SERVICE BULLETIN # 1073

SUBJECT FUEL TANK VENT TUBE

MODEL 1-70, 1-80 DATE 10-1-59

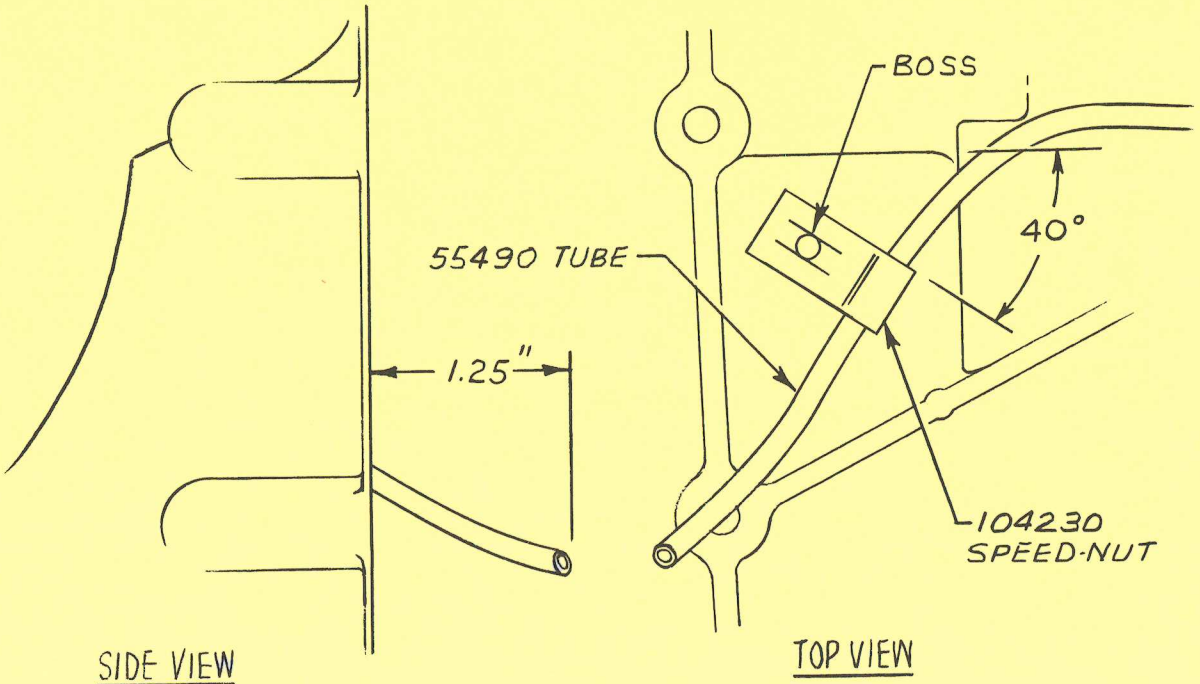
There have been reports that the fuel tank vent tube, P/N 55490, which is a component part of the fuel tank bottom assembly, P/N 55499, is being damaged or broken in parts order shipments enroute from the factory. In each case, the damage has been due to the upright position of the vent tube which is fastened securely in place by the speednut, P/N 104230.

To avoid the possibility of the vent tube being damaged, all future parts orders, for the fuel tank bottom assembly, will be shipped with the vent tube taped against the fuel tank bottom casting and not held in place by the speednut.

The speednut will be packaged separately (in a small envelope) in the fuel tank bottom assembly, and it will be necessary to install the speednut when service replacement of the fuel tank bottom assembly is required. To correctly install the speednut, do the following:

1. Place the vent tube in position in fuel tank bottom as shown in illustration below.

2. Measure the length of the vent tube that extends beyond the casting edge of the fuel tank bottom (see illustration below). It should be 1-1/4 inch in length.

3. Press the speednut on th e boss in the fuel tank bottom. Make sure the speednut holds the vent tube firmly in place.
